MEMORANDUM

SUBJECT: ZC #12-01E – Catholic University – Campus Plan Amendments and Further

Processing for a New Solar Energy Facility

Office of Planning Public Hearing Report, ZC #12-01E Catholic University Solar Energy Facility – Campus Plan Amendment and Further Processing December 21, 2021

Excerpt from approved
Campus Plan: "Proposed
Master Plan", p. 67, showing
proposal for the West Campus,
and alternative with parking
lot removed.

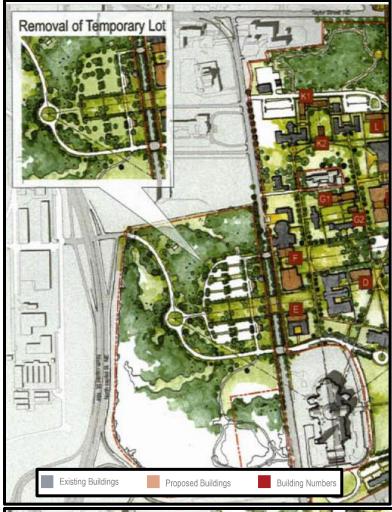
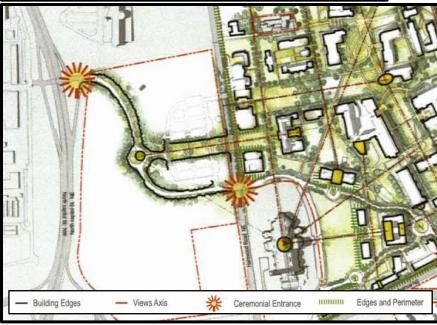
The proposal would require a campus plan amendment to permit the solar array in this location. The array would replace, in the plan, a view and landscape corridor focused on Caldwell Hall, intended as an organizing element for future building development on the West Campus. The solar facility would also replace a proposed temporary parking lot, as well as the planned ceremonial entrances to campus from North Capitol and Harewood Road. The following excerpts from the campus plan illustrate what uses and organizing elements were approved on the subject site.
